National Electricity Transmission System Security  
and Quality of Supply Standards (NETS SQSS)

# GSR014: Review of Requirement of Onshore Connection Facilities for Offshore Wind Farm Connections: Industry Consultation

Based upon the results of the GSR014 Work-Group, this proposal seeks to modify NETS SQSS Section 7.13.1.1: Onshore Connection Facilities: AC Circuits.

Figure 1. Schematic diagram of the offshore transmission system designs considered.

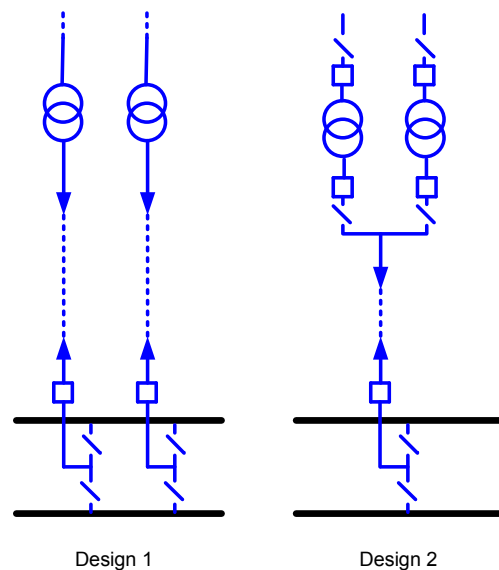
- 1.1 The GSR014 Working-Group has conducted a cost benefit analysis (CBA) using the Spackman<sup>1</sup> approach to determine the optimum design of offshore transmission connections to onshore electricity networks. Specifically, the CBA considered whether two HV switch-bays (Figure 1 Design 1) or one HV switch-bay (Figure 1 Design 2) should be installed where the offshore wind farm connects to the onshore transmission network.
- 1.2 For the purpose of this analysis it was assumed that the onshore elements for the connection of the offshore transmission system, for which schematic diagrams are presented in Figure 1 below, would operate at 400kV. Furthermore, such systems shall comprise of underground cables, circuit breakers, disconnectors, transformers and the onshore substation that connects the offshore system to the onshore system.

- 1.8 The Spackman approach was used to compare the costs and benefits between Design 1 and Design 2, both shown in Figure 1 above.
- The capital costs used were the transmission investment costs of each design. The transmission capital costs were converted into an annual cost using the IDC value of 7.9%. This produces a stream of financing costs or an appropriate time profile of annualised costs.

- 1.9 The results show that using the Spackman approach, Design 1 gives a higher NPV benefit compared to Design 2 when tested over a range of generation capacities for both AIS and GIS switchgear designs.

- 2.7 The GSR014 Working-Group investigation didn't show that the single bay option was economic. In fact, there was a firm cost benefit case for Design 1 (i.e. two bays). The proposed change to the NETS SQSS will make the use of Design 1 clearer. In practice the vast majority of offshore designs have adopted this two bay approach already. The proposed NETS SQSS changes will formalise the position.

**7.13.1.1** *With effect from 31<sup>st</sup> December 2014, in the case of new offshore power park module only connections, and where the offshore grid entry point capacity is 120MW or more, following a planned outage or a fault outage of a single AC offshore ~~transformer~~ transmission circuit at the onshore AC transformation facilities or between the onshore AC transformation facilities and the Onshore Transmission System, the loss of power infeed shall not exceed the smaller of either: 50% of the offshore grid entry point capacity; or the full normal infeed loss risk. (For the avoidance of doubt, connection offers signed by all parties before 31<sup>st</sup> December 2014 for connections which are configured with two AC transformers banked onto a single 400kV or 275kV switch-bay are deemed to be compliant with Section 7.13.1.1.)*
